VILLAGE OF GERMANTOWN
N112 W17001 MEQUON ROAD, GERMANTOWN, WI 53022

MEETING:	PLAN COMMISSION
DATE AND TIME:	MONDAY, MARCH 8, 2021 6:30 p.m.
LOCATION:	Germantown Village Hall Board Room N112 W17001 Mequon Road

- B. Venture Construction Group, Agent for SRN Properties, Property Owner of Automation Solutions N116 W18627 Morse Drive. Site Plan Review for a 6,200 sqft Industrial Building Addition.
[ACTION]

Village Planner Report

SITE PLAN

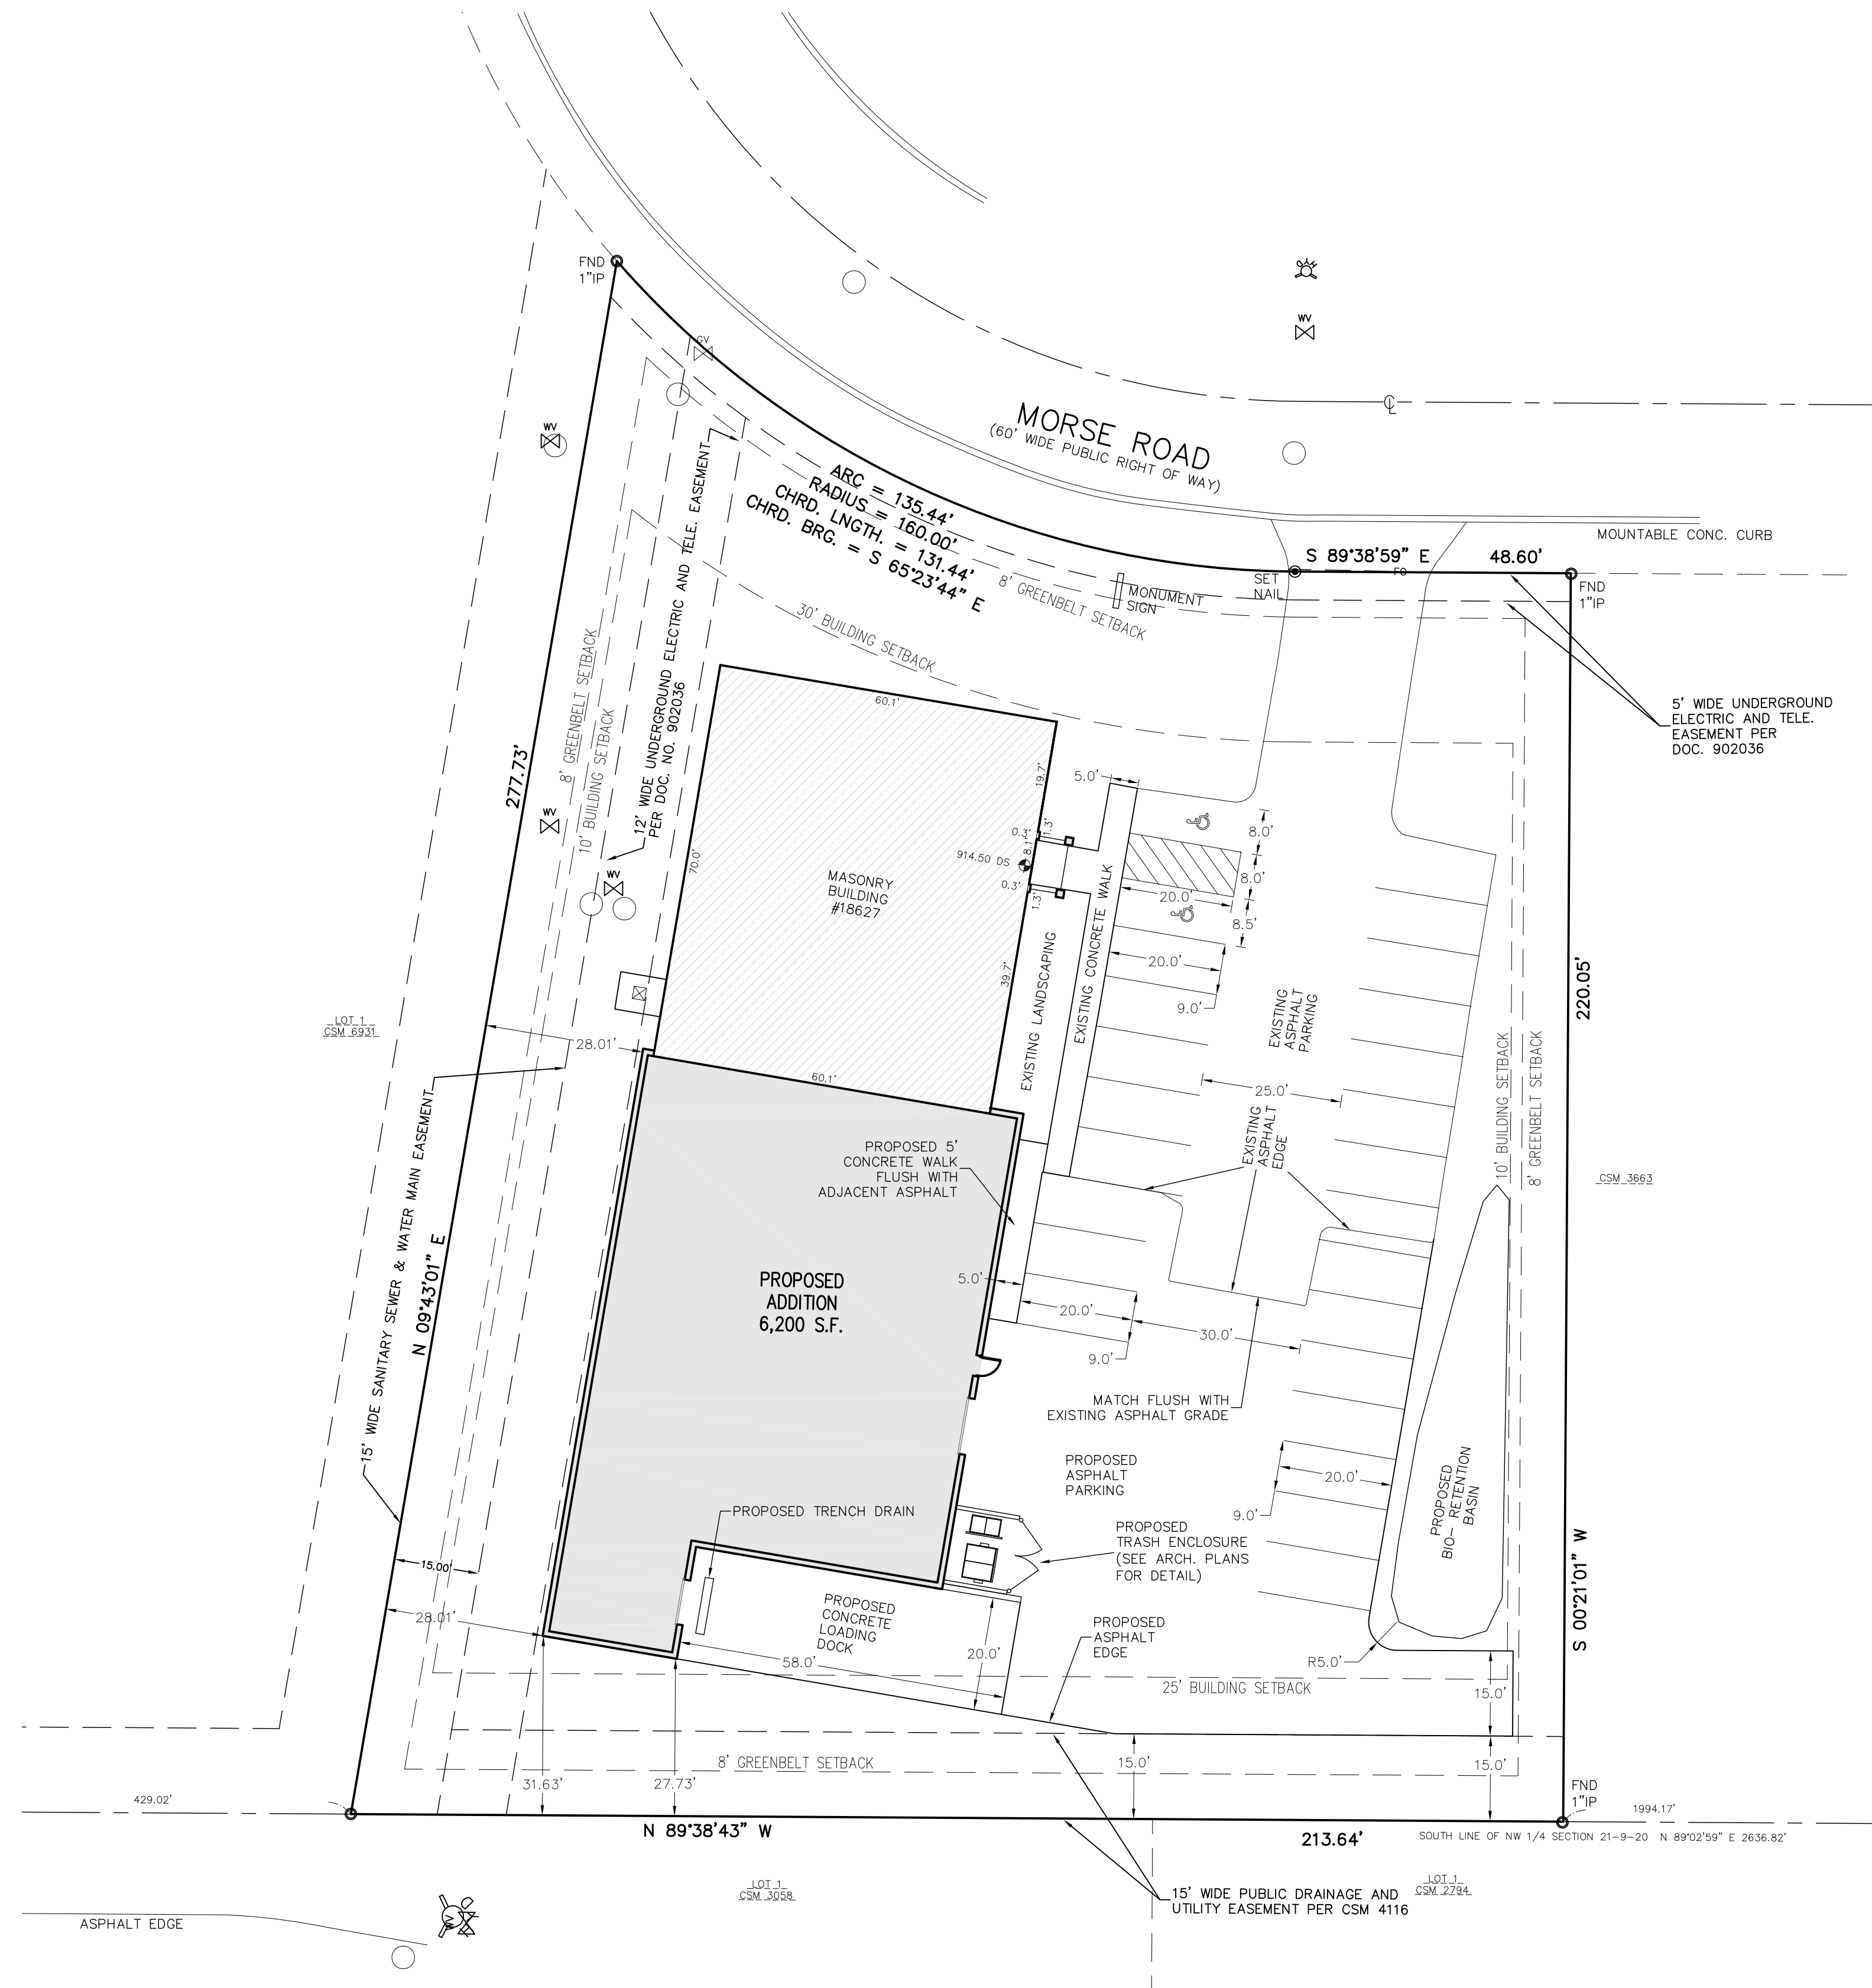
4. Although the size of the Automation Solutions expansion in terms of additional impervious area does not exceed the Village and MMSD threshold for requiring storm water management facilities for the site, the Village Code allows the Village Engineer to require a storm water management analysis, plan and possibly facilities for any development project with an increase in impervious area that may have an adverse impact on the Village’s existing drainage facilities (in this case the Blackstone Creek regional basin). Consequently, the Village Engineer and Public Works Director are recommending that the owner choose one of two (2) alternatives with respect to storm water management impacts from this project:

- a. Provide the necessary storm water calculations (including surveying and modeling of the Blackstone Creek basin drainage basin) that indicate the Blackstone Creek regional basin can handle the additional storm water

flow expected as a result of the proposed building and parking lot expansion; or

- b. Provide the necessary storm water calculations and resulting on-site stormwater management facilities necessary to reduce (or at least not increase) peak flows from the site with the proposed building and parking lot expansion. Since there is already a bio-retention basin proposed, a storm water management analysis and report indicating that the proposed bio-retention basin will reduce (or not increase) peak flows at or below the current condition.
